Addendum No. 1

RE: Contract # C204082

Dare County (F-5700)

Construct 183'-7" X 46' X 10'-6" Passenger/Vehicle Ferry

MAIN DECK BULKWARKS

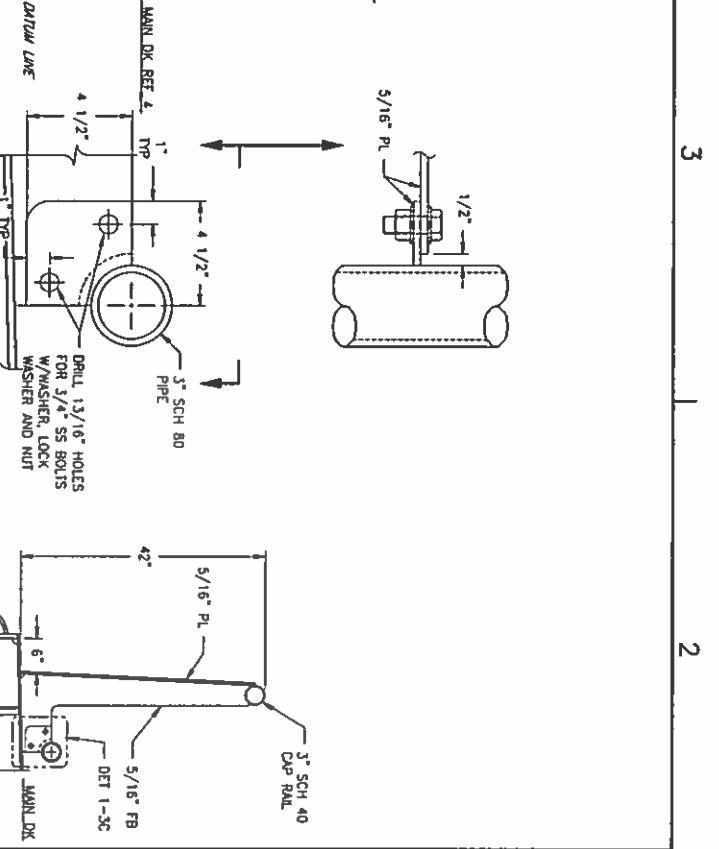
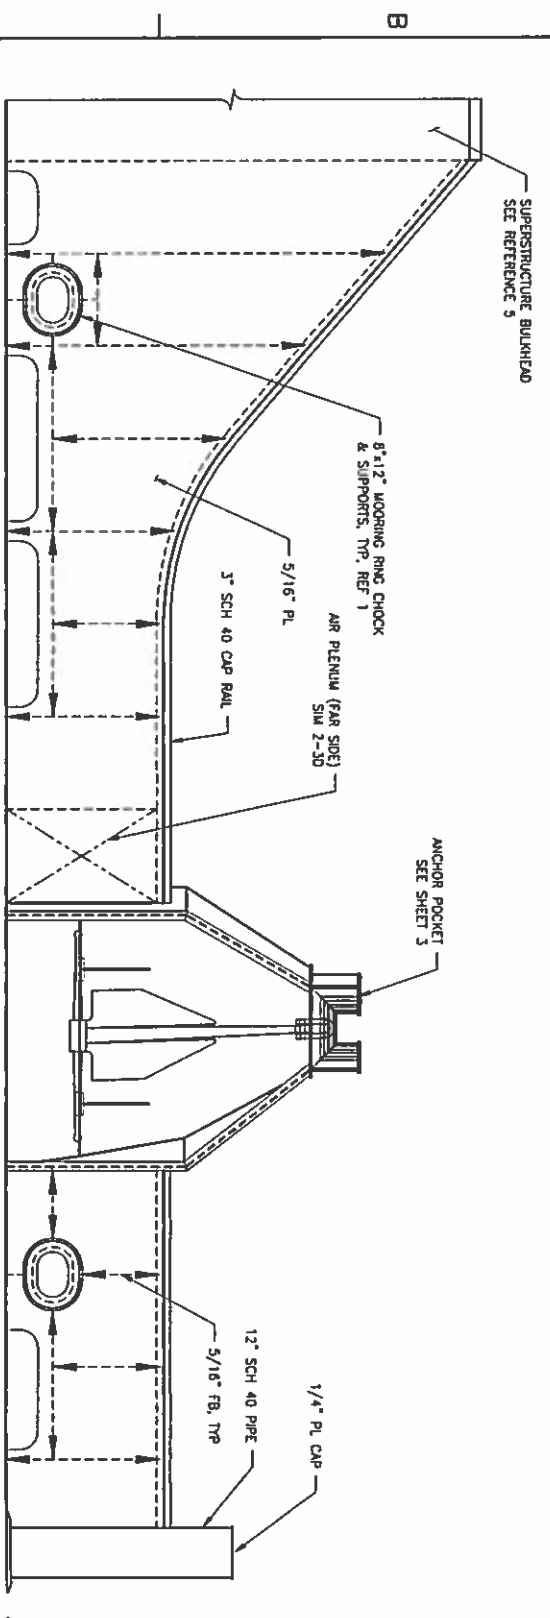
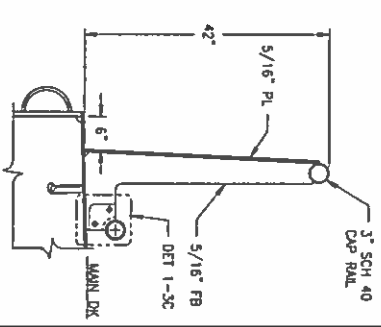
REVISION HISTORY				
REV	ZONE	DESCRIPTION	DATE	APPROVED
A	1-3C	1. UPDATED FE STAMP FOR REV A 2. ADDED DETAILS FOR BULKWARK CONNECTION TO RUB RAIL.	08/31/17	KAJ

MASTS

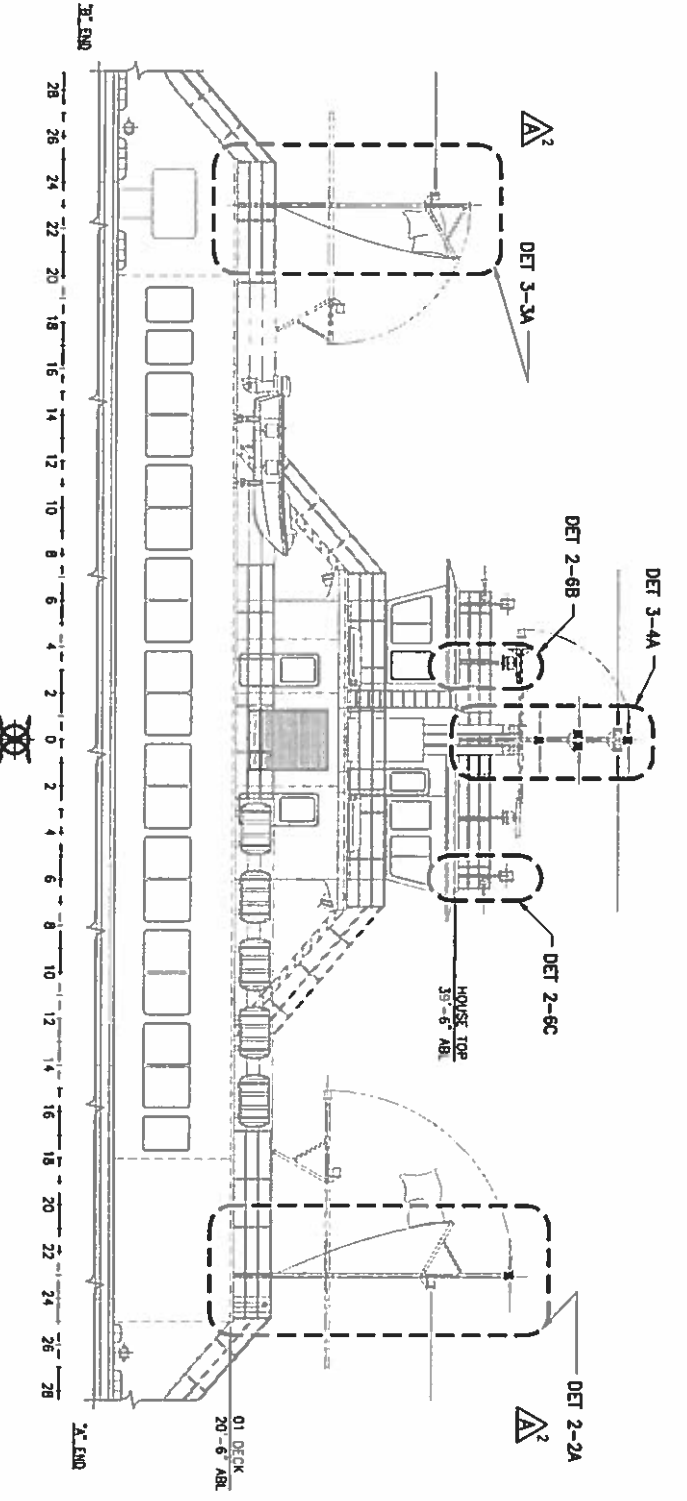
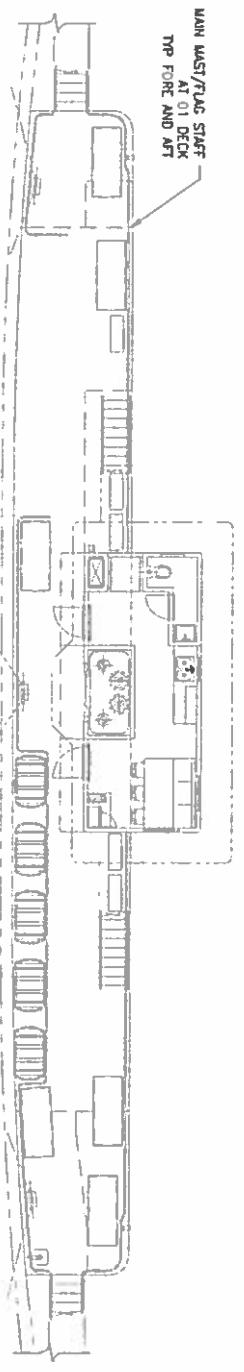
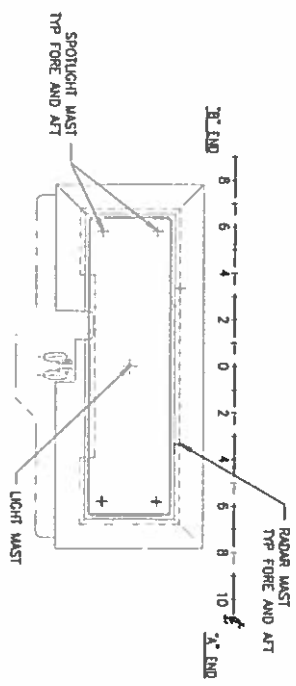
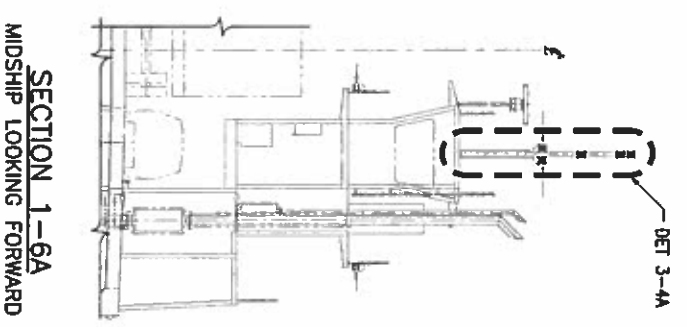
150-1: Sheet 4, Zone 5C	Added louver description
	Main Deck Bulwarks
150-3: Sheet 1, Zone 3C	Added details for bulwark connection to rub rail
	Masts
170-1: Sheet 1, Zones 3B & 5B	Updated location of main masts to Frame 23
170-1: Sheet 2, Zones 2B & 3B	Updated location of main masts to Frame 23
	Fuel Oil Piping Schematic
261-1: Sheet 2 (general) & Zone 3B	Removed tank penetration symbols from return lines and increased size of supply cross-connect from 2" to 3"
	Navigation Light Arrangement and Block Diagram
422-1: Sheet 2, Zone 3B	Relocated masts to Frame 23
	Fills, Vents, and Sounds
506-1: Sheet 2, Zone 4A	Removed fill cross-connect pipe between fuel tanks
	Machinery Ventilation Arrangement
513-1: Sheet 1, Zones 6A & 6B	Revised emergency generator size and airflow and void louver dimension
	Fire Main System Schematic
521-1: Sheet 1, Zone 3C	Added Note 21
	Bilge and Ballast Schematic
529-1: Sheet 1, Zone 3C	Added Note 22

DATE	16101-200-513-1	REV	B
SCALE AS NOTED	16101-200-513-1B	SHEET	1 OF 4
DATE	8/31/2017	DATE	7/28/17

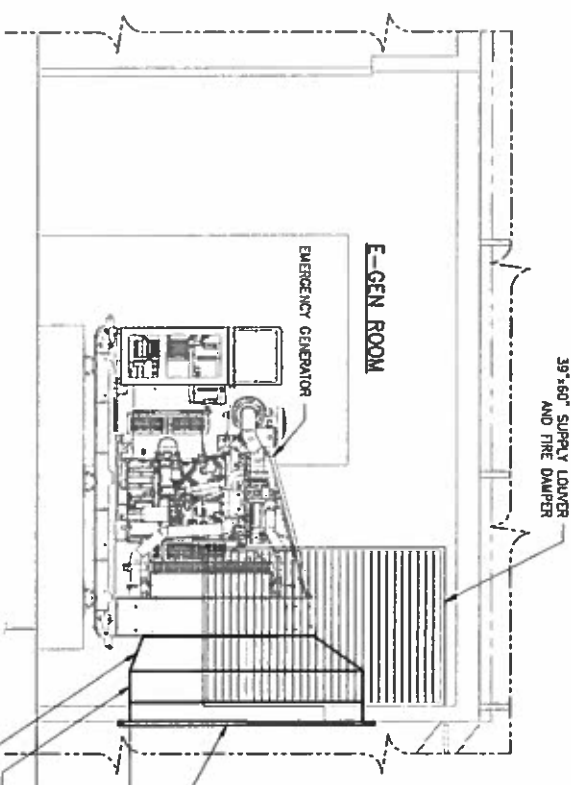
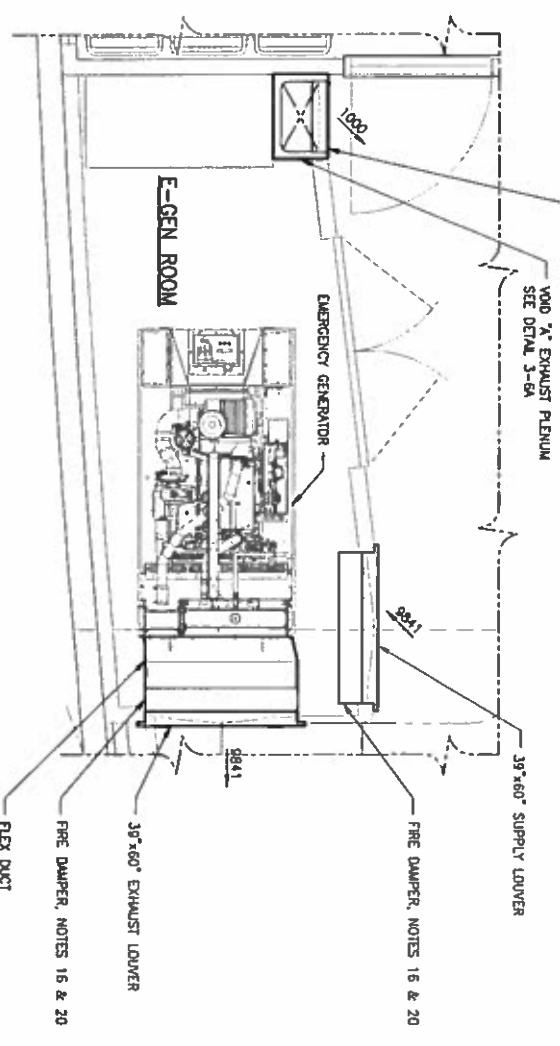
REV	ZONE	DESCRIPTION	DATE	APPROVED
A	1-6A	REVISED EGEN LOUVER AND AIRFLOWS, WAS 39X50 AND 10,171	8/2/17	MEJ
B	1-6B	UPDATED LOUVER DIMENSIONS	8/30/17	DKG
				MEJ

PLAN 3-3A
BALLAST SYSTEM DIAGRAM

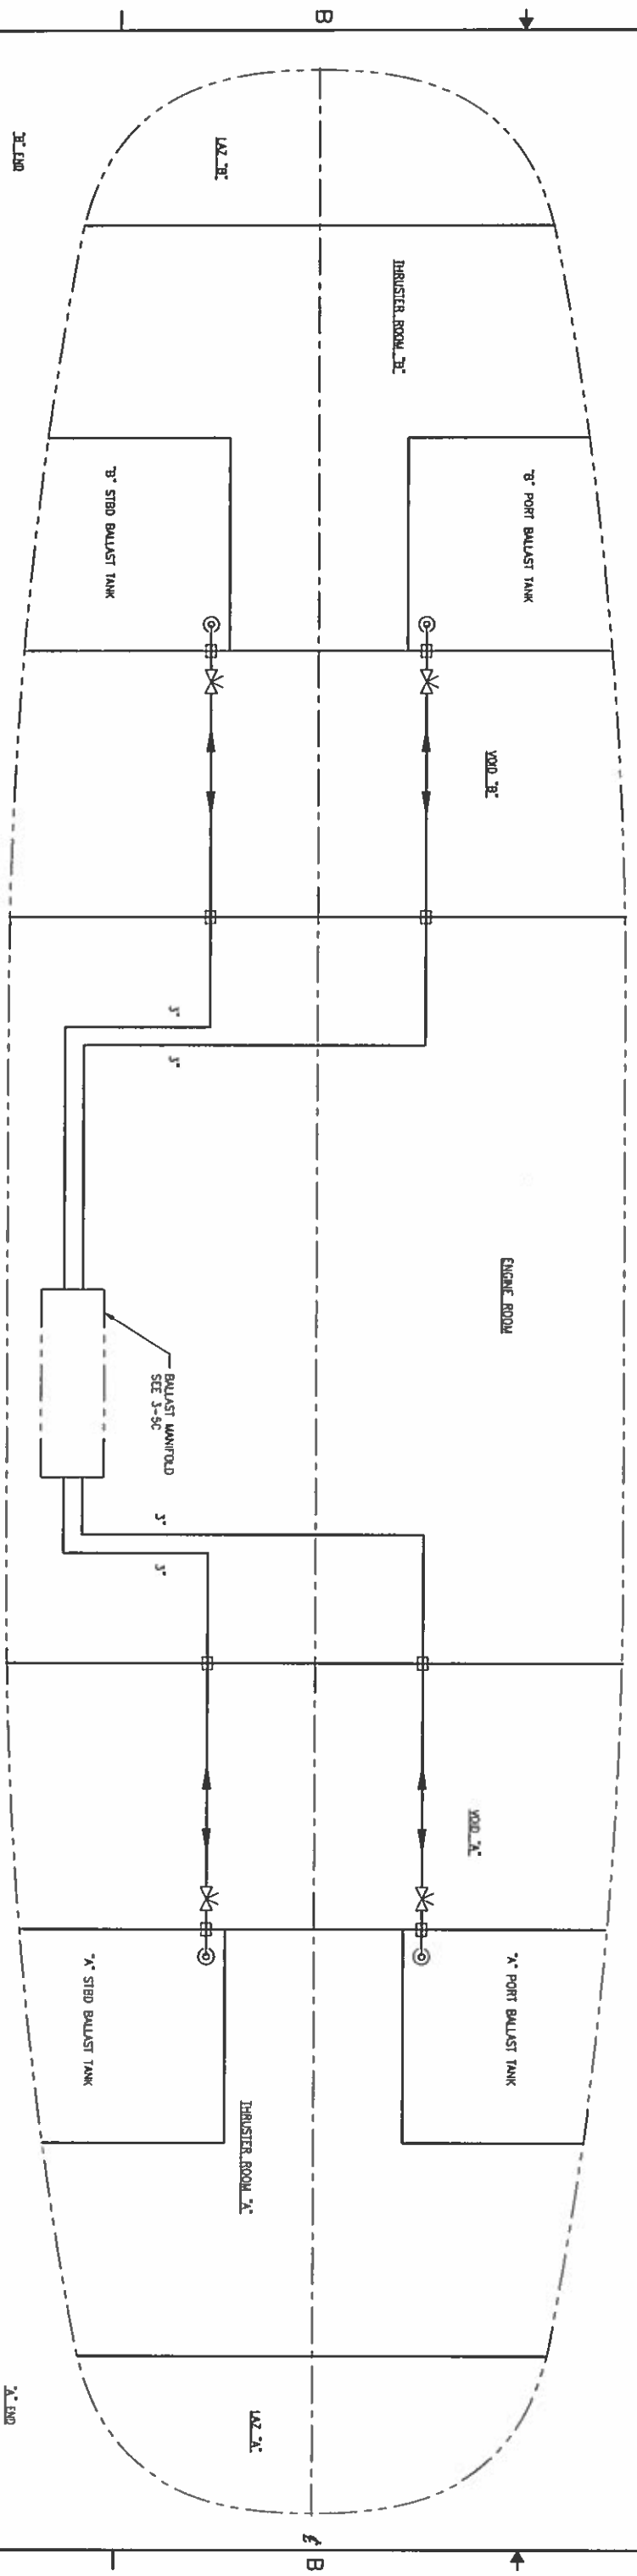
529-1: Sheet 3, Zone 3A	Revised ballast suction locations to reflect low point of each tank
	Hatch Schedule
624-3: Sheet 1, Zone 6C	Added hatch at Frame 21, B-End starboard
624-3: Sheet 2, Zone 4C	Added hatch at Frame 21, B-End starboard

REV	ZONE	DESCRIPTION	DMN	DATE	APPD
1	3-SA	REvised BALLAST SUCTION LOCATION	LCB	8/30/17	LCB
2	1-3C	ADDED NOTE 22.

HATCH SCHEDULE

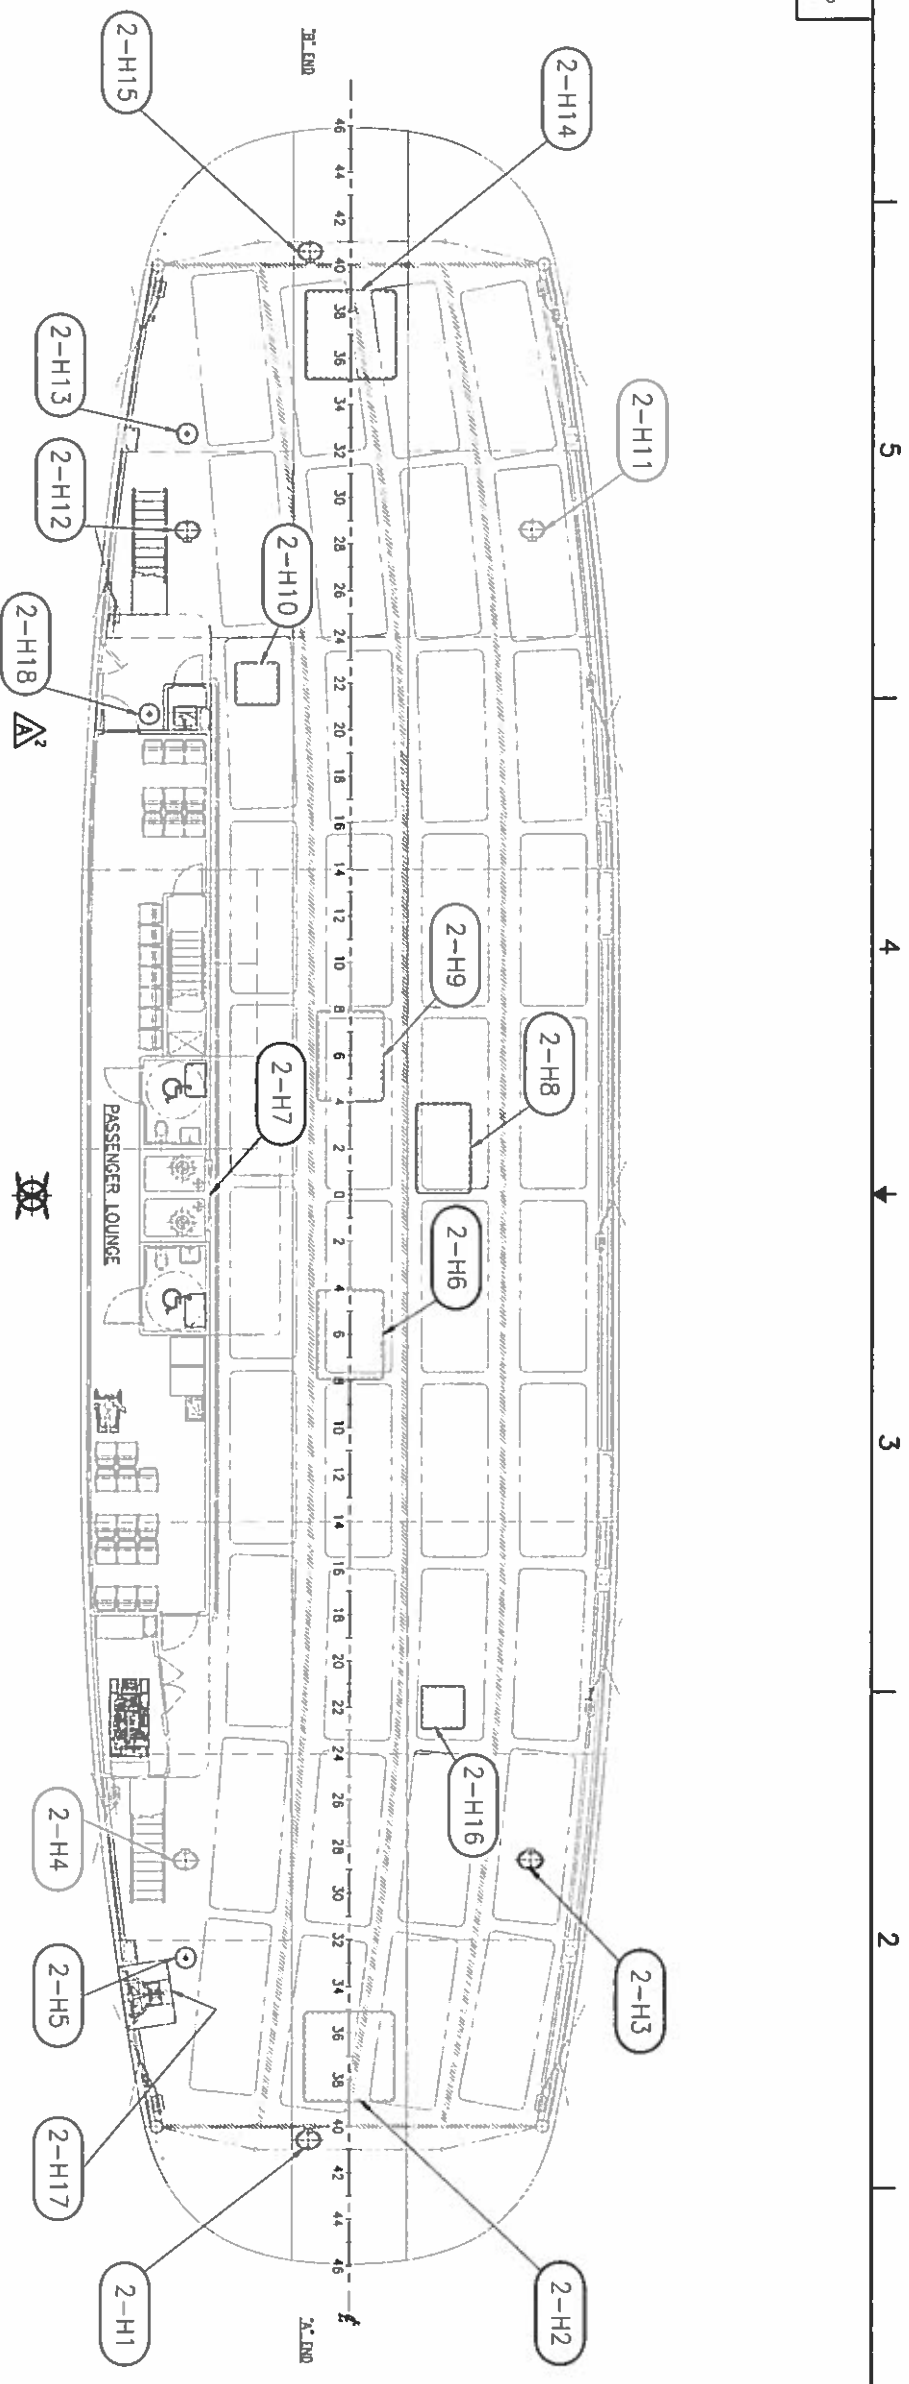
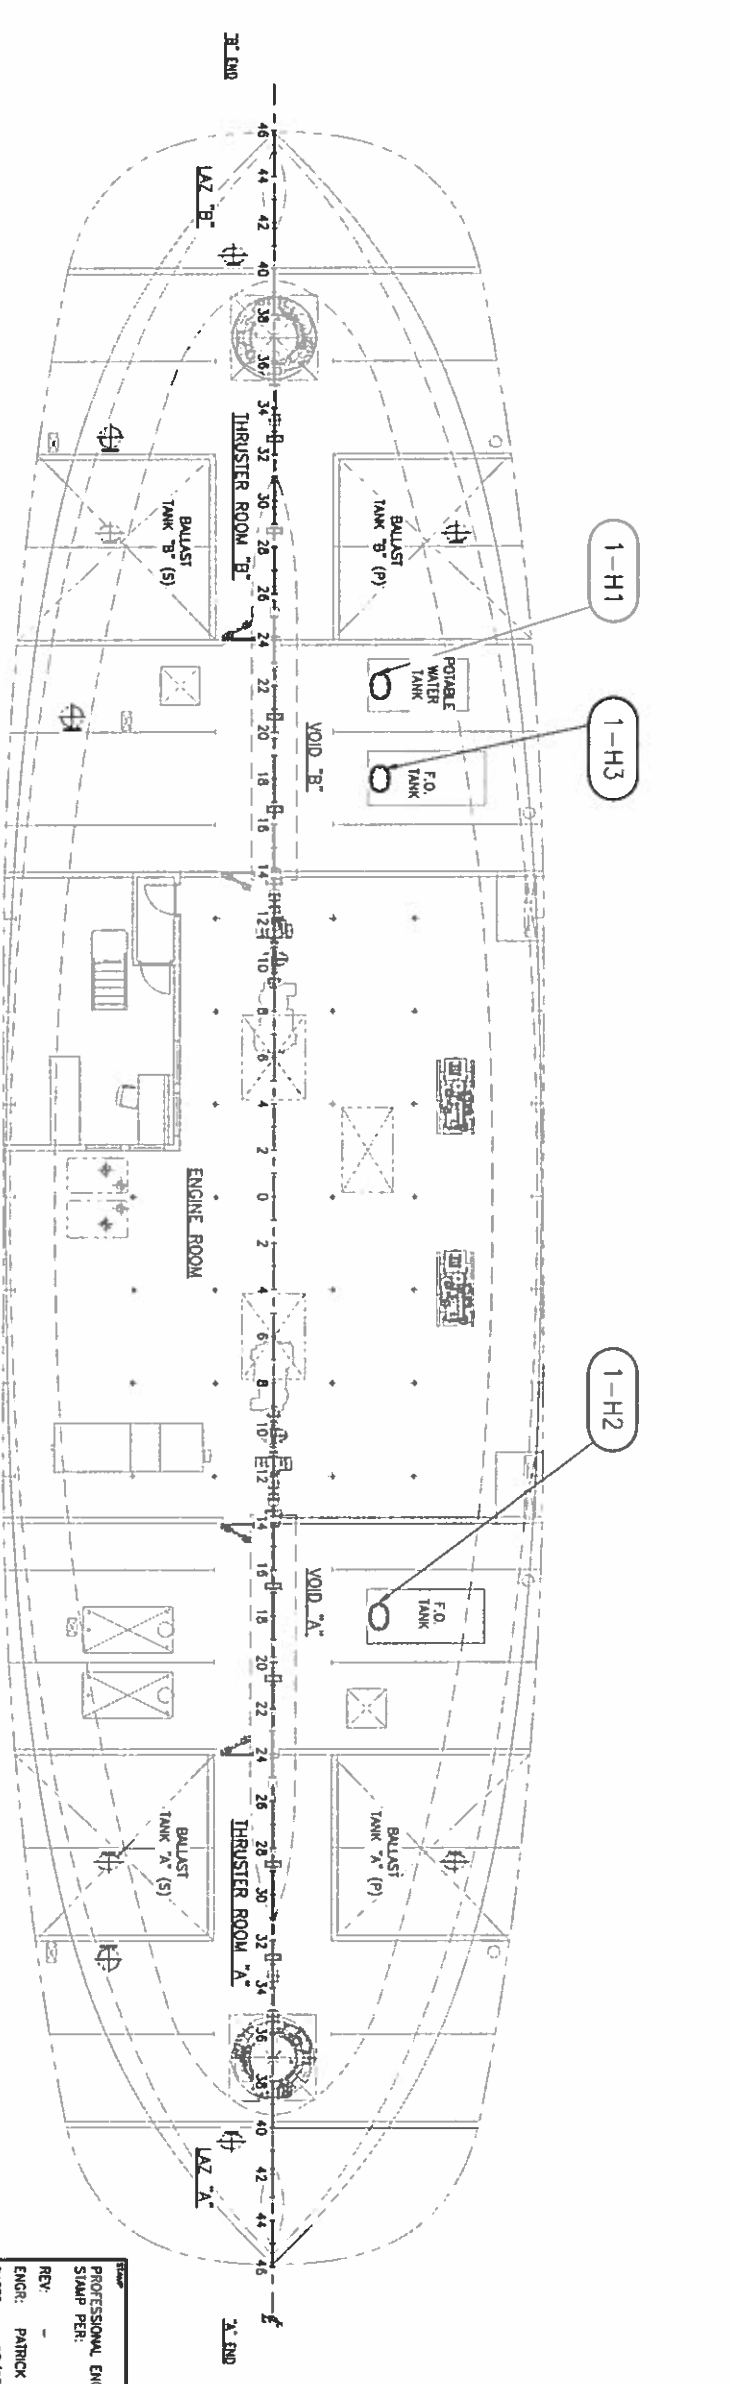
REVISION HISTORY			
REV ZONE	DESCRIPTION	BY	DATE
A	1. UPDATED PE STAMP FOR REV A	DKC	08/31/17
2-4C	2. ADDED HATCH AT PR 21 B END STRD.
